# PENTAVIA, MILL HILL

## TECHNICAL NOTE: RESPONSE TO BCC COMMENTS

CLIENT: HEALEY DEVELOPMENT SOLUTIONS (MILL HILL) LTD

DATE: APRIL 2019

**Figure 3: Cycle connection to the south**

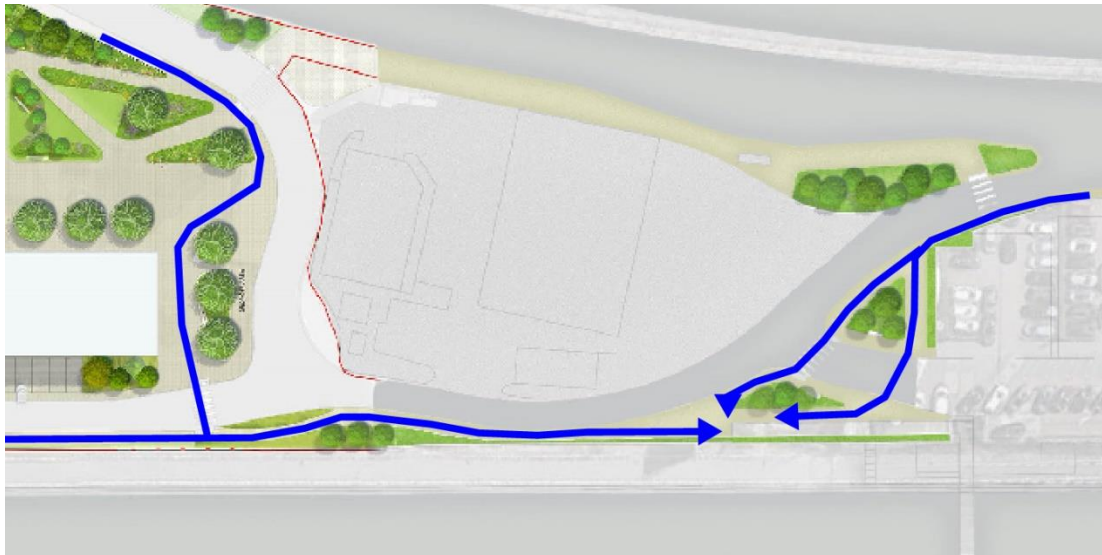
*“Exiting and entering the site towards Grahame Park Way means crossing a bridge. No provision in the plans has been made for access to this bridge from the slip roads. Riders are presented with either crossing the slip road near a blind bend or exiting the entire site to the north and returning, crossing both slip roads. Additionally, access to the bridge is via the trade entrance to a car dealership.”*

18. In conjunction with the provision of the new shared route to the west of the BP petrol filling station, the revised plans have sought to improve the access arrangements at the base of the ramp. **Figure 3** indicates the proposed connections achievable by cycle.
